**Re: Affordable housing development – Corner of Browning Street and Bangalow road
Byron bay – Deferred Development Consent conditions 10.2020.651.1**

As requested, We have reviewed the Deferred development consent conditions in relation to on site vehicle access. We report as follows:

DRAWING TITLE MRV TRUCK SWEEP PATH			
DESIGN PBL	DRAWN WSA	DRAWING SCALE 1:100	SHEET SIZE A1
PROJECT REF NO. 210343	DRAWING NO. VT1	REVISION A

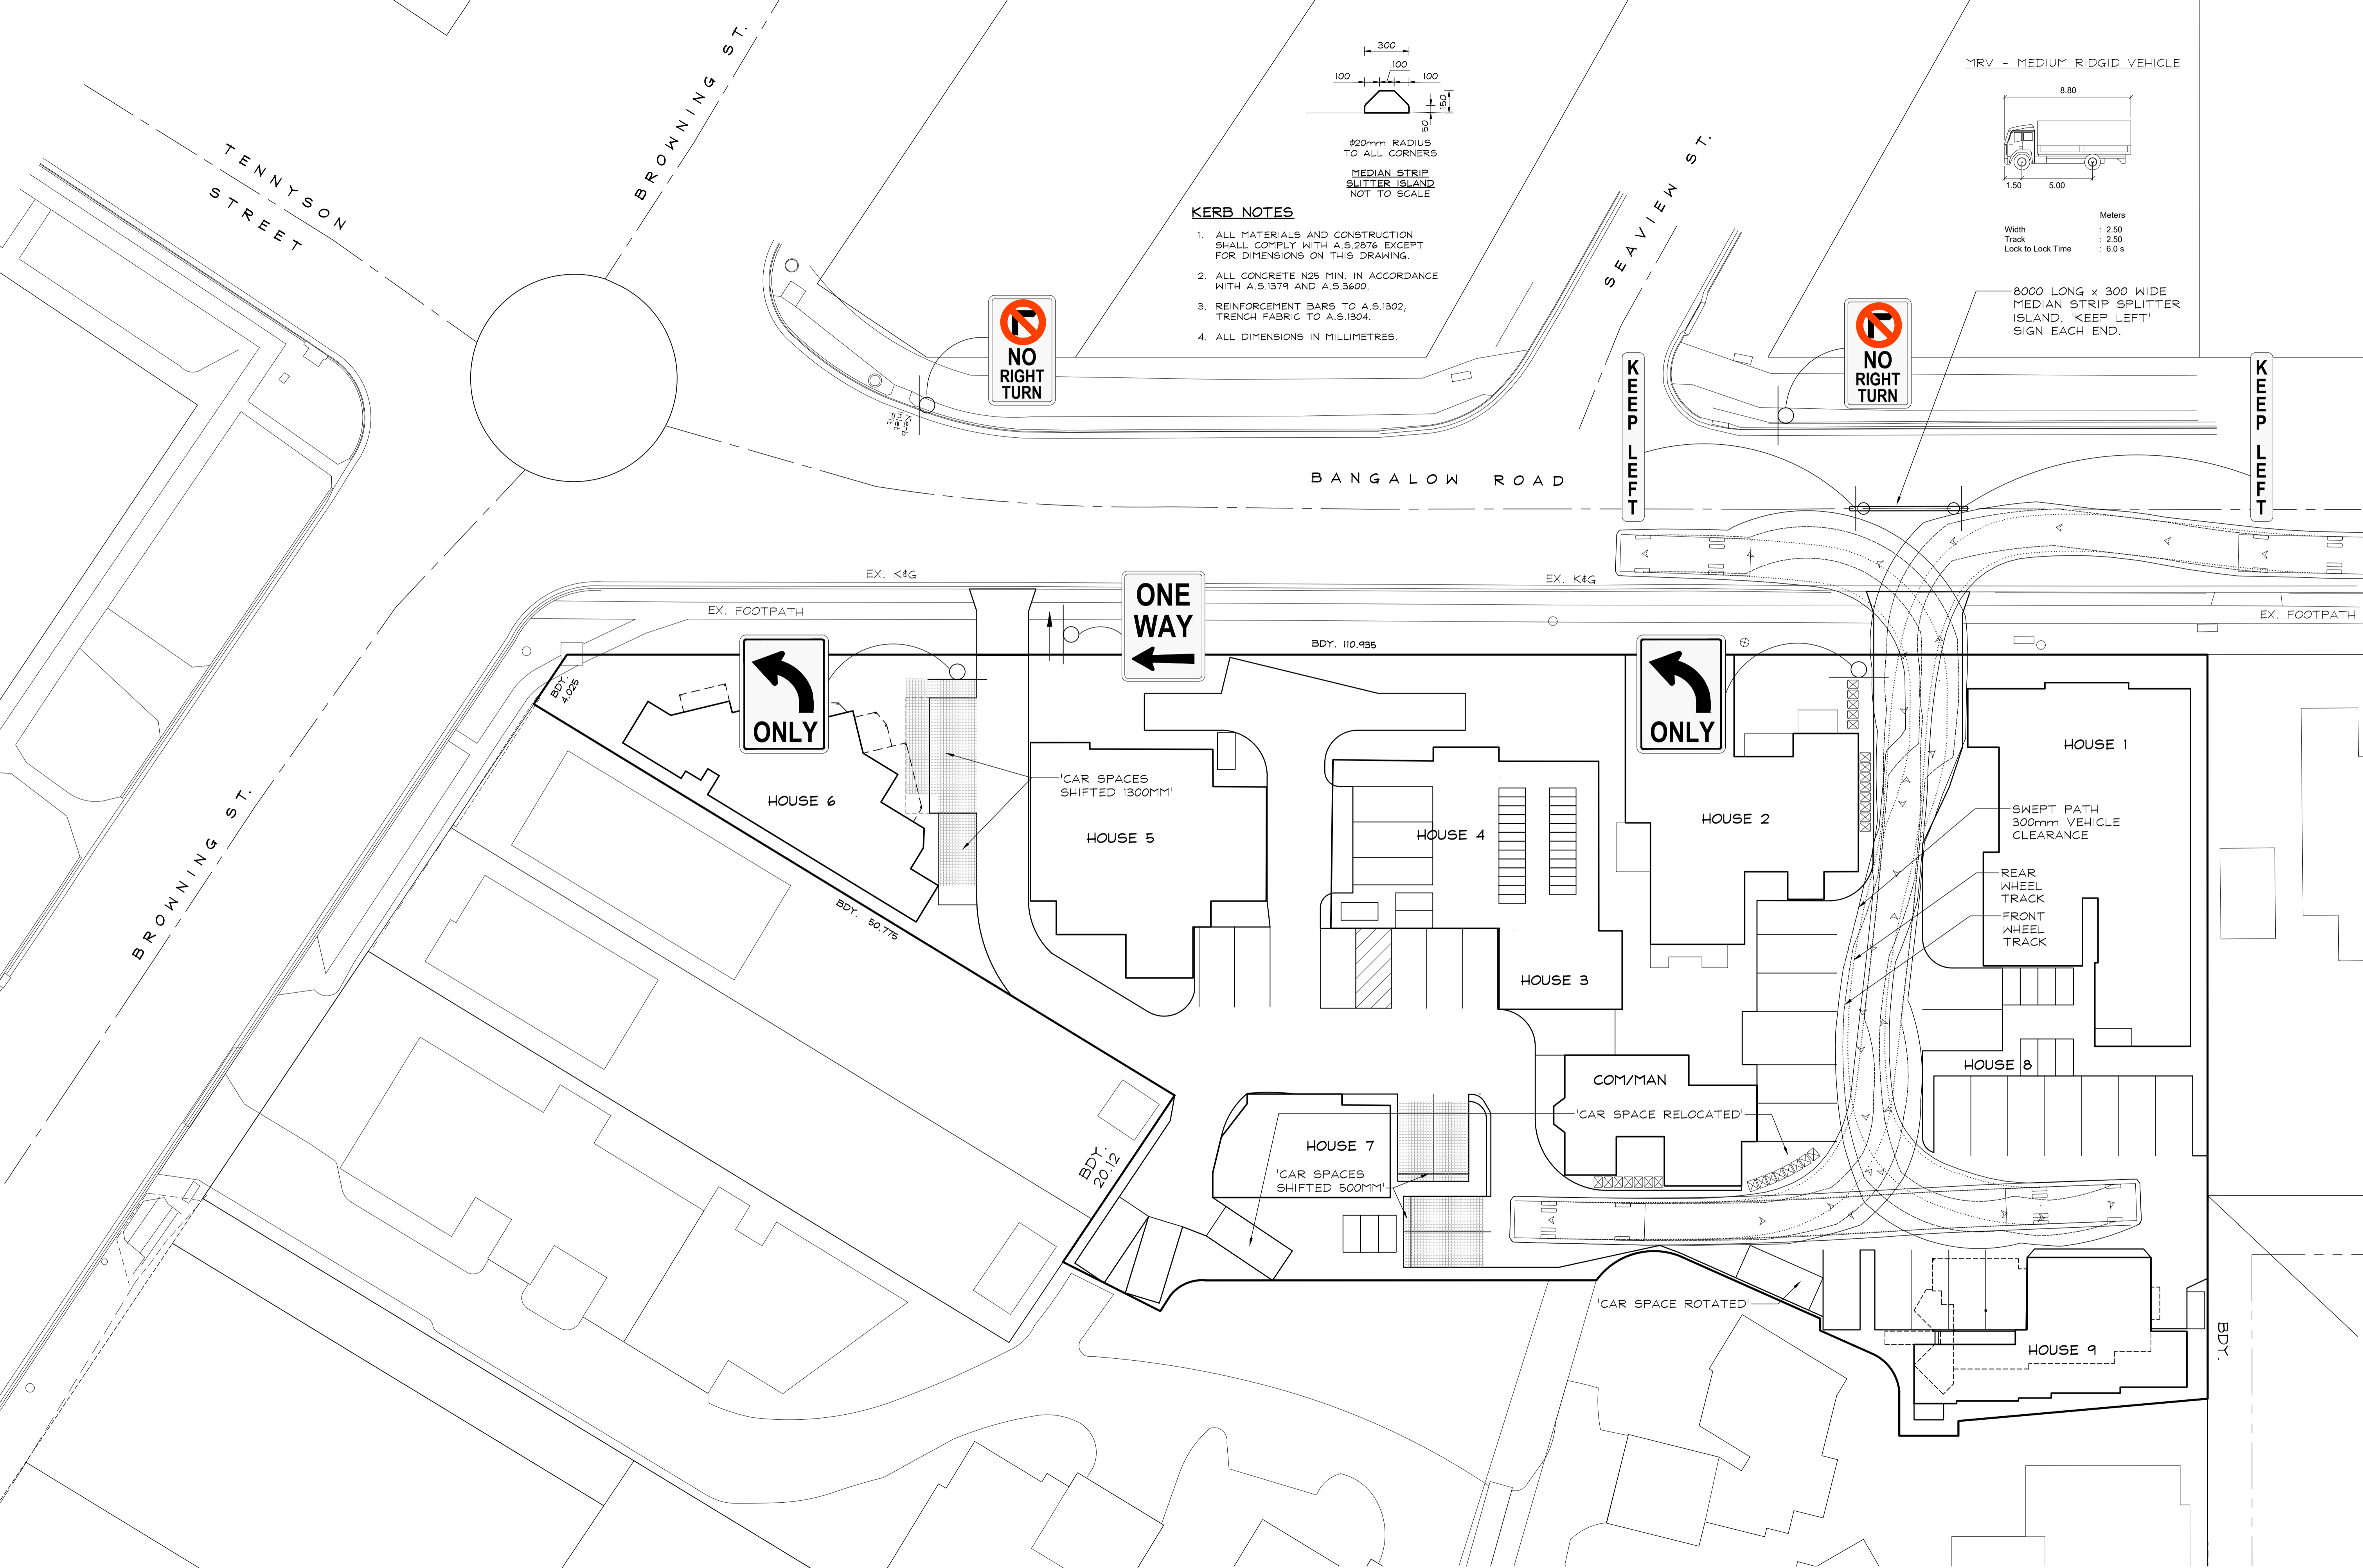
We note that the condition specifies that the clearance requirement for commercial vehicles is to be 0.5m. We also note that the condition immediately following states compliance with AS2890. We make the following points in regard to these:

1. The clearance requirements in AS 2890.2 – commercial vehicles are for vehicle turning paths to have 0.3m clearance when manoeuvring in and out of loading bays, and 0.3m clearance when travelling on the access pathway, with an additional 0.3m clearance on the outside path on any curved sections of the access road. Please refer to the code condition below.
2. The Deferred development condition in question is an increase on the requirements of the Australian Standard.
3. In regard to this site, given the constraints of the required access, we consider it reasonable to meet the detailed requirements of AS 2890 part 2.
4. The additional clearances specified in the deferred consent condition are an unreasonably onerous additional requirement, in our view.

5. We have shown the required pathway on our attached drawings for the SRV and the proposed MRV access to the site, in compliance with the AS2890 criteria, for your reference.
